**INVITATION FOR BIDS (IFB) #25-019
EAST LAKE CLUBHOUSE APARTMENTS RENOVATION**

ADDENDUM NUMBER ONE (1)

ADDENDUM NO. ONE (1)

RE: Exterior Repairs at East Lake Club Apartments
150 East Lake Club Drive
Oldsmar, Florida 34677

Issue:		FOR CONSTRUCTION	
Architect's Project No.:		202534	
Drawn By:		CF/AS/IG	
Checked By:		RW	
Date:		11/18/2025	
Sheet Title:			
WINDOW DETAILS AND SCHEDULE			
Sheet Number:		Revision No.:	
A-502		R1

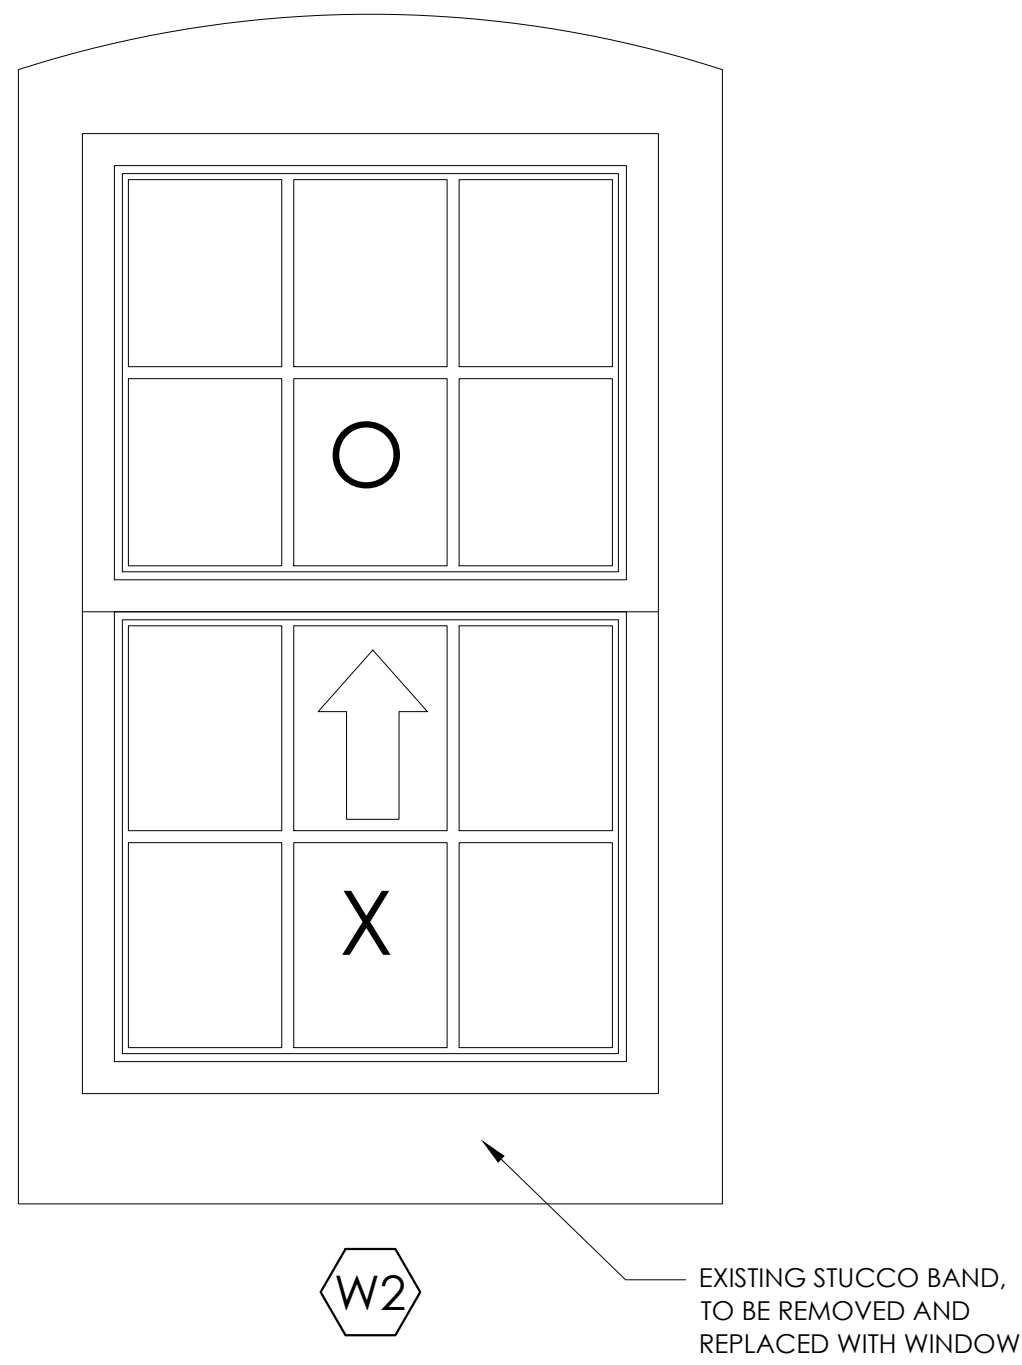
5. Refer to Drawing Sheet A-502R1; Revised and enclosed.
6. Refer to Drawing Sheet A-503 and A-504, Detail 2; Contractor to remove existing marble sill (clean and save for reuse) and reinstall after installation of new window.
7. Refer to Drawing Sheet A-503 and A-504, Detail 2, Notes 7 and 19; The intent of the documents is to repair all new finishes. Contractor to match existing colors and assume in the bid proposal that paint will blend into existing paint finishes no less than 12-inches from the area of work.
8. Refer to Drawing Sheet A-505R1; Revised and enclosed.

FOR CONSTRUCTION	
Architect's Project No.:	202534
Drawn By:	CF/AS/IG
Checked By:	RW
Date:	11/18/2025
Sheet Title:	
FOUNDATION WALL AND SCREEN DRAIN DETAILS	
Sheet Number:	Revision No.:
A-505	R1

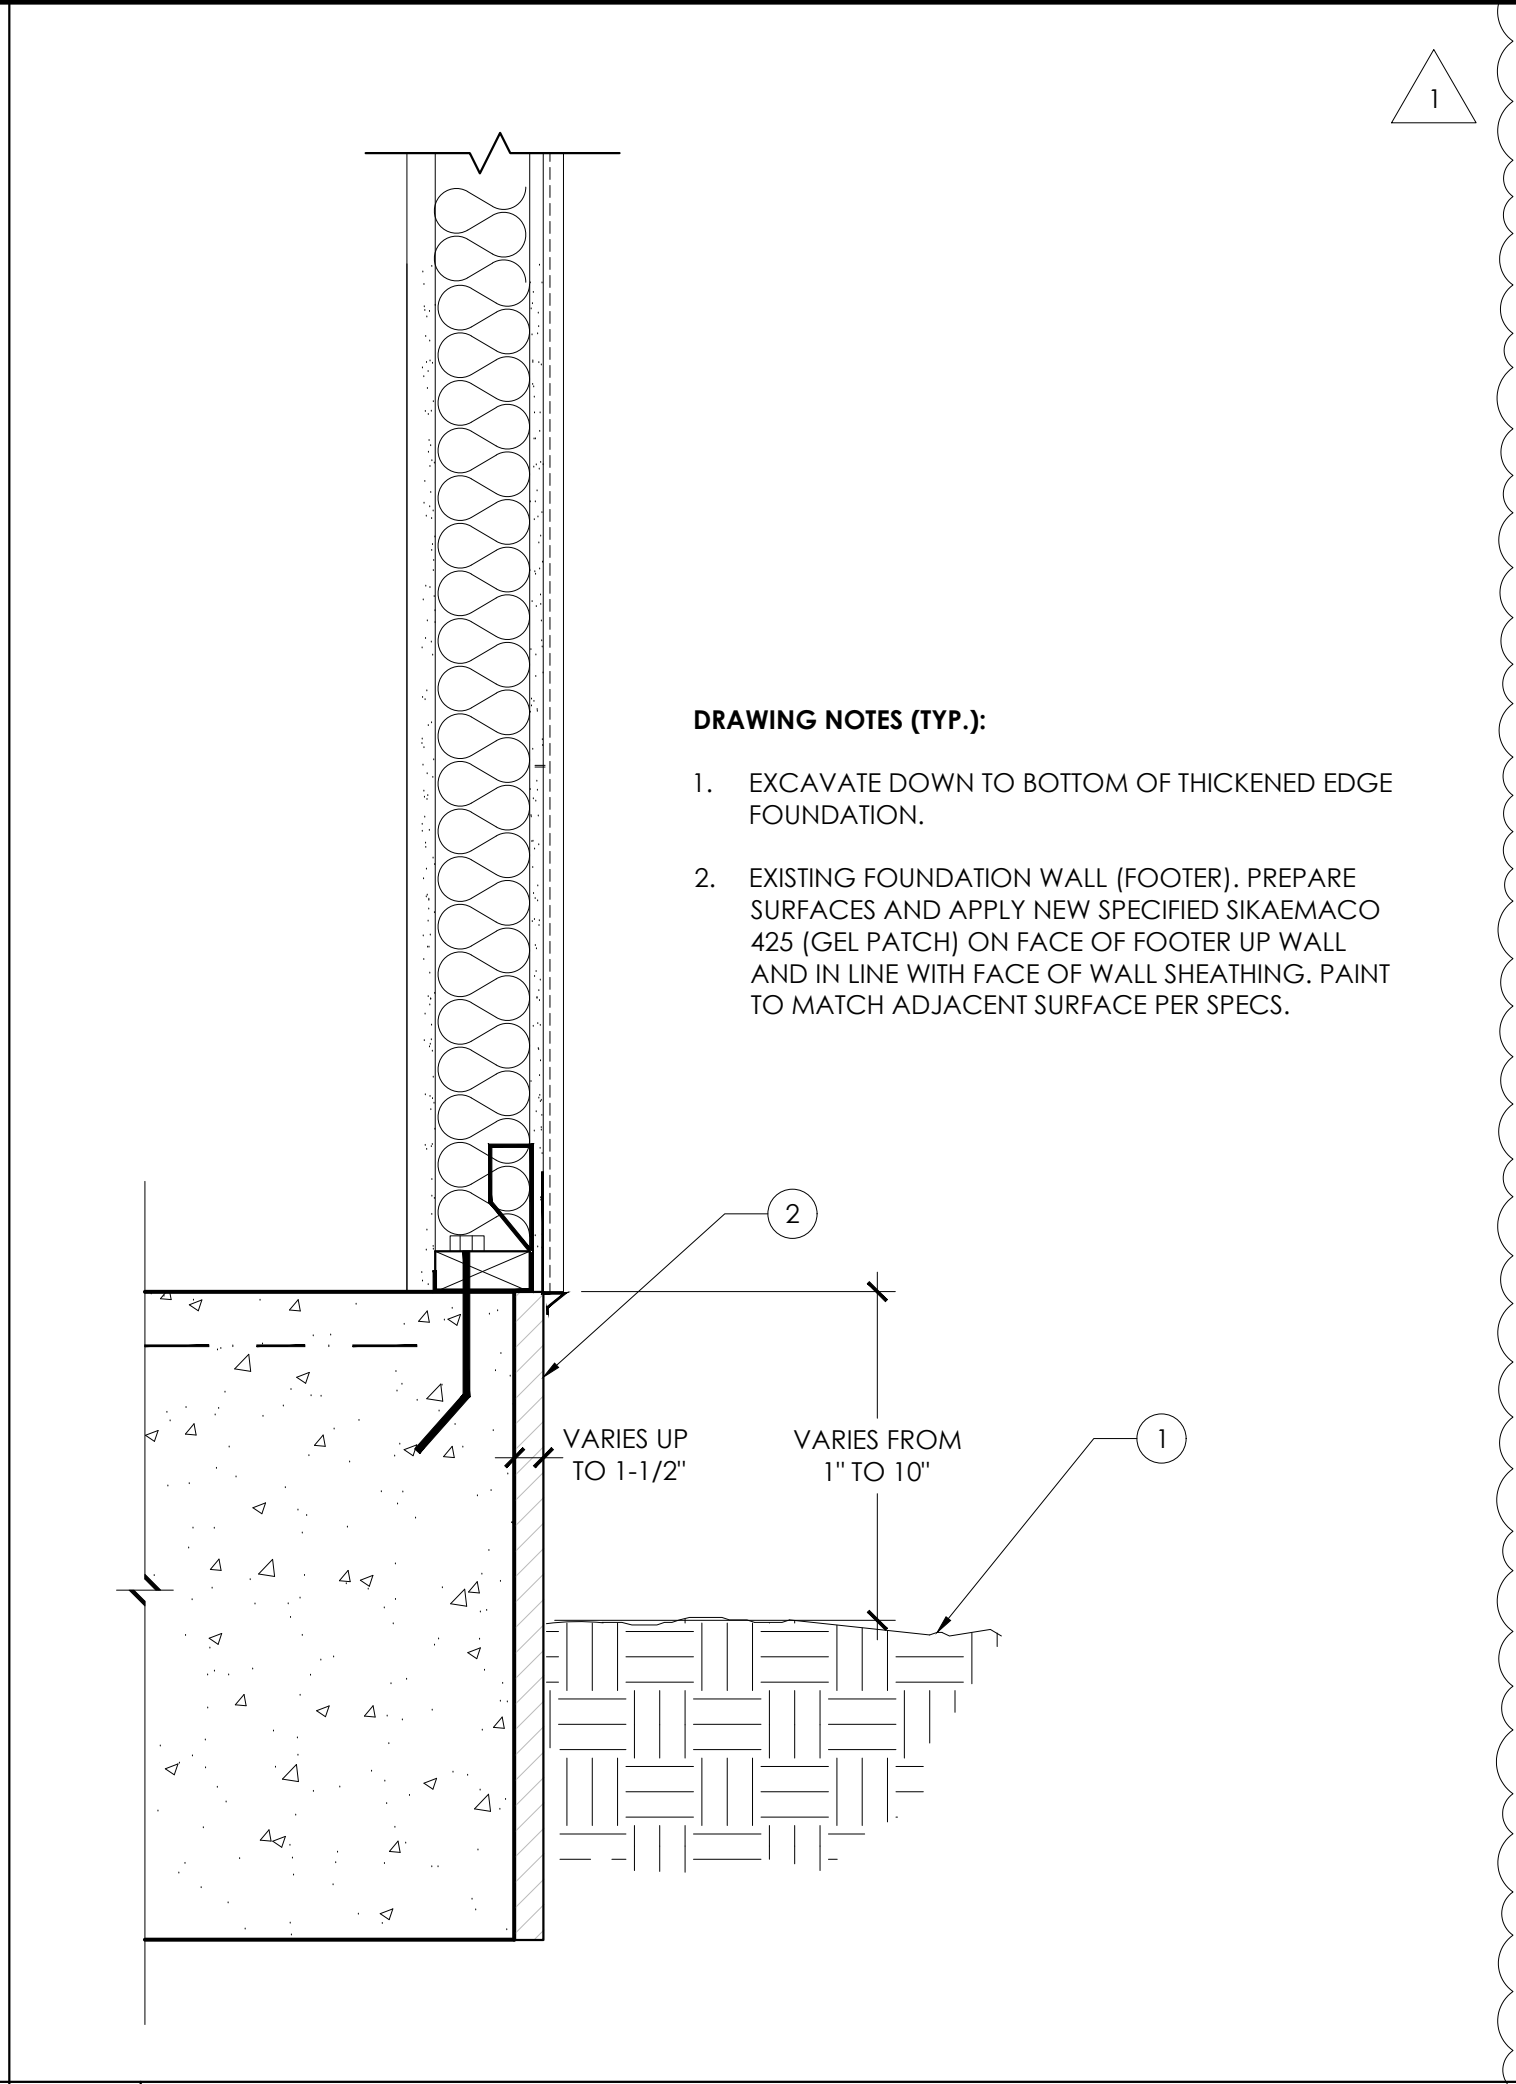
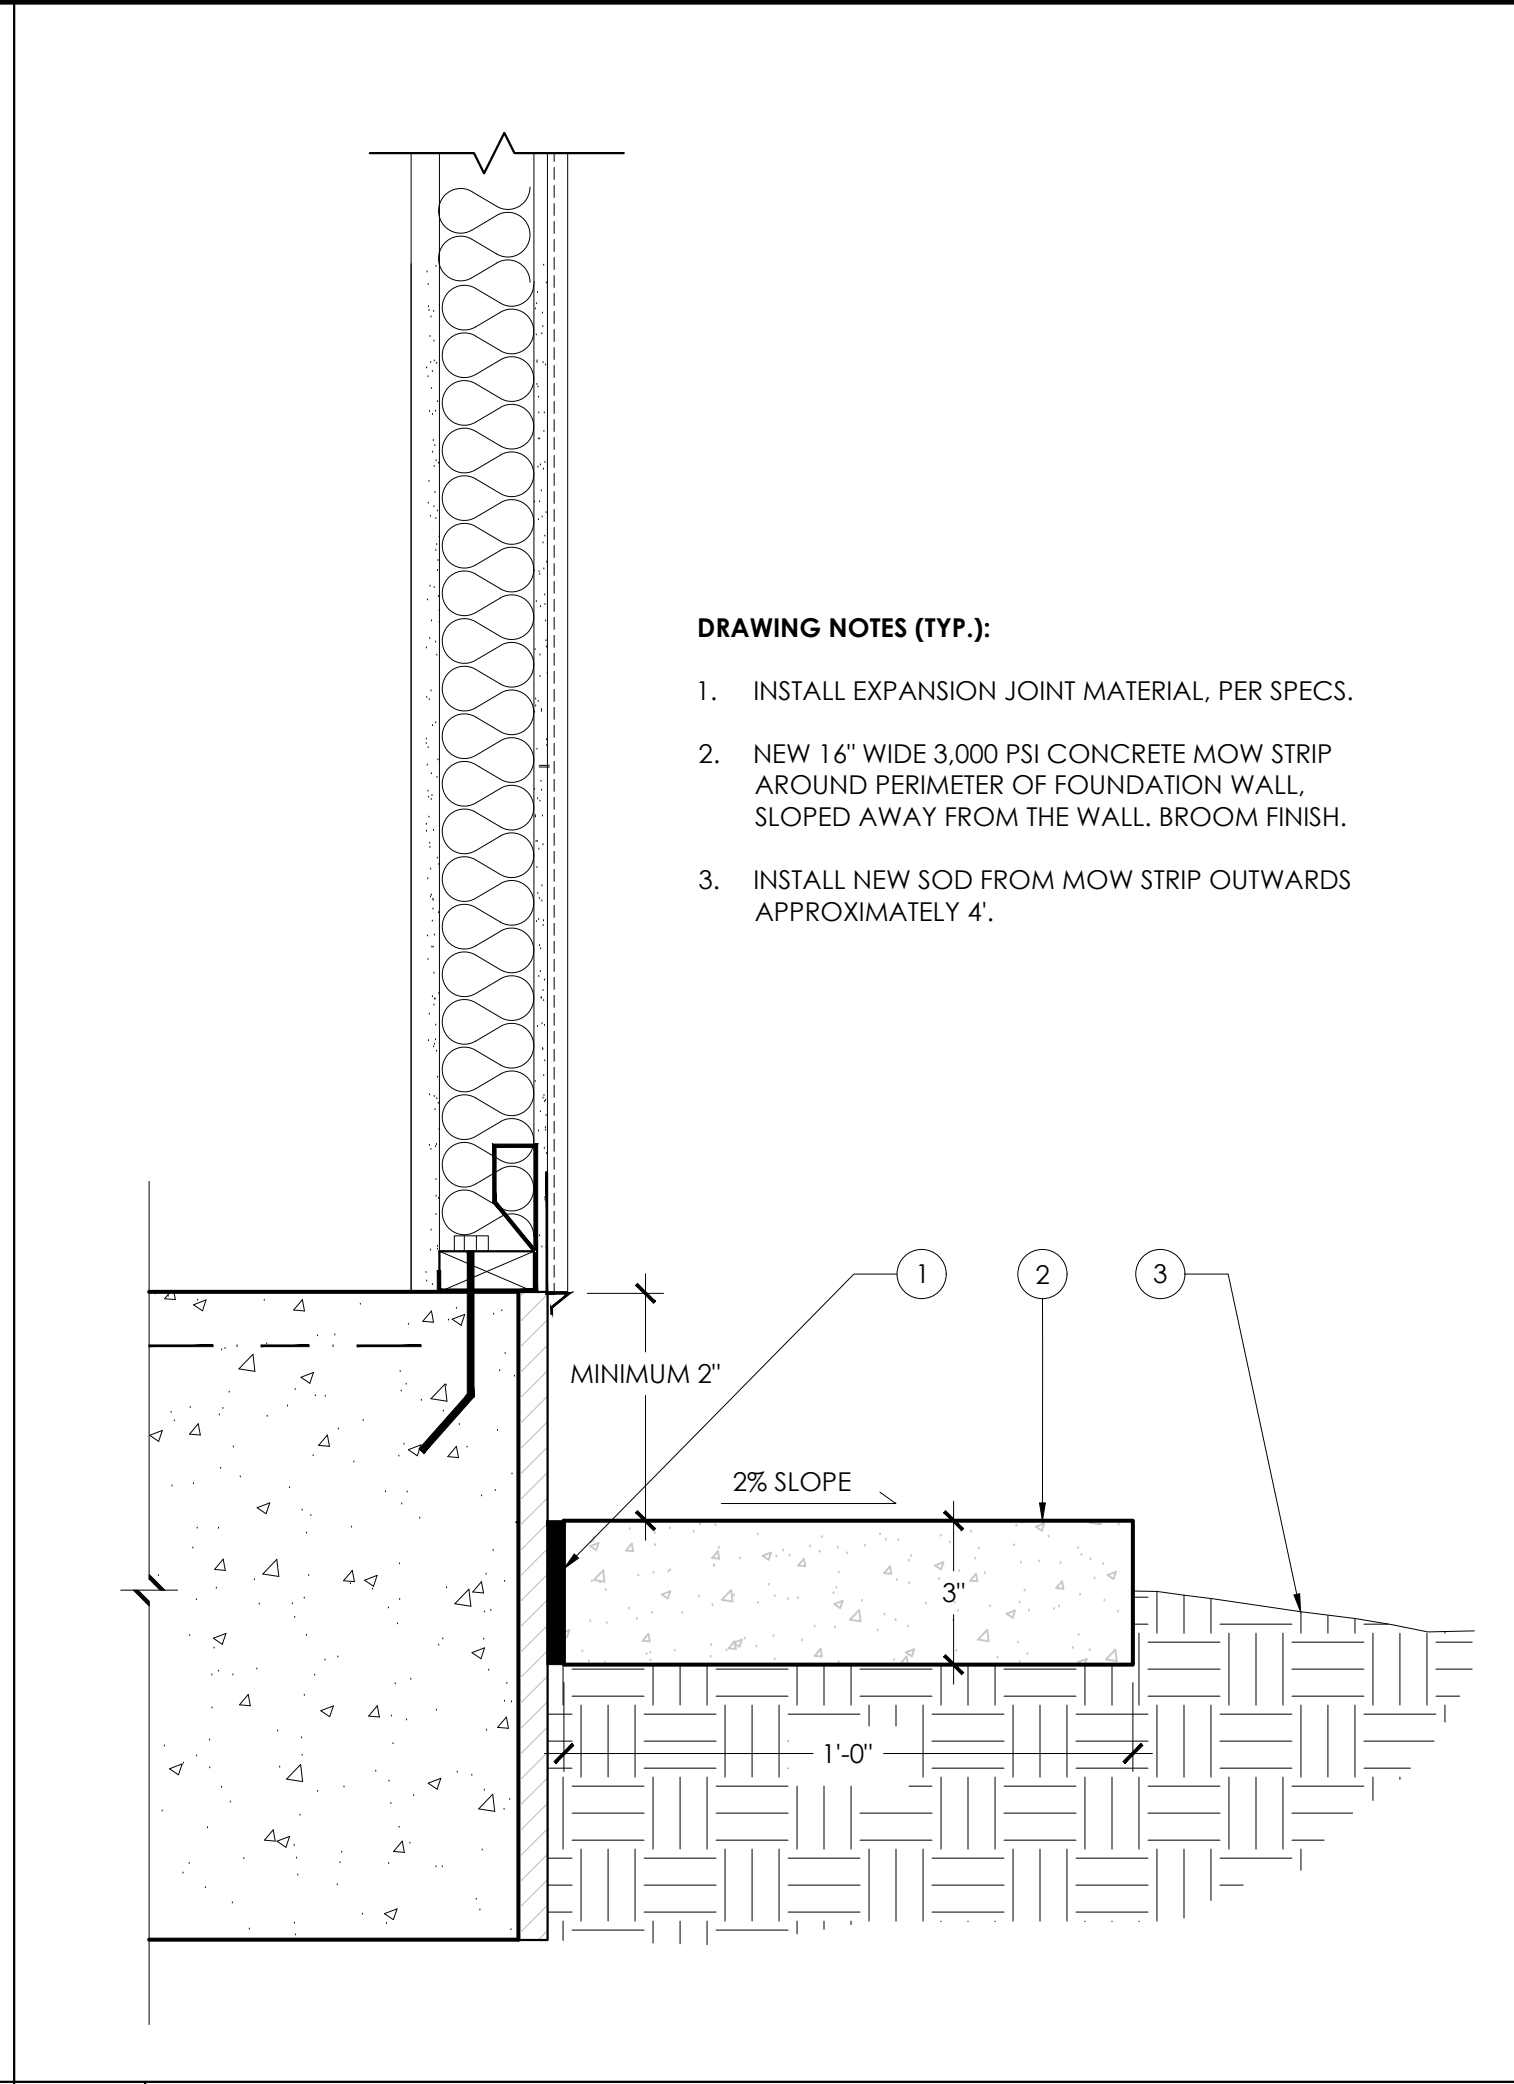
2. Refer to Specification Section 01 11 00, Para. 1.04.E.13; Revise Item 'b' to read as follows:
 - b. Rework grading, install gel patch along foundation wall, and install new concrete mow strip per Details on Sheet A-505. Document, remove, salvage, and store any irrigation items (e.g. piping, sprinkler heads) in area of new mow strip for future modification/reinstallation.
3. Refer to Section 01 11 00, Para. 1.04.E.14.b which states, "Temporarily remove light fixtures and/or ceiling fans at patio ceilings to be restored, save for reuse. Reinstall after painting work is completed. Electrical work to be performed by Florida licensed electrician." This is a general note and would only apply where ceiling fans or lights are present. After review of the existing conditions, there does not appear to be any electrical fixtures at the end balconies.
